Commission of Architectural Review SUBMISSION APPLICATION

November 18, 2015

E. Clay Street nond, Virginia

106 E. Richmol

PHASE 2: SECTION at REAR PORCH SCALE: 1/2" = 1' - 0"

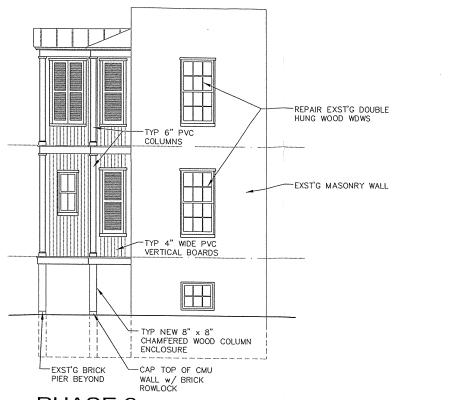
The only revision to the project that was submitted in July 2015 is to change the piers supporting the rear porch structure from brick to chamfered wood piers. The chamfered wood will cover structural steel columns.

> -7" x 7" x 1/2" GALV BASE PLATE BOLT TO CMU WALL w/ 1/2" BOLTS ON EACH 3 1/2" x 3 1/2" GALV STEEL TUBE COLUMN TYP NFW 8" x 8 CHAMFERED WOOD COLUMN ENCLOSURE
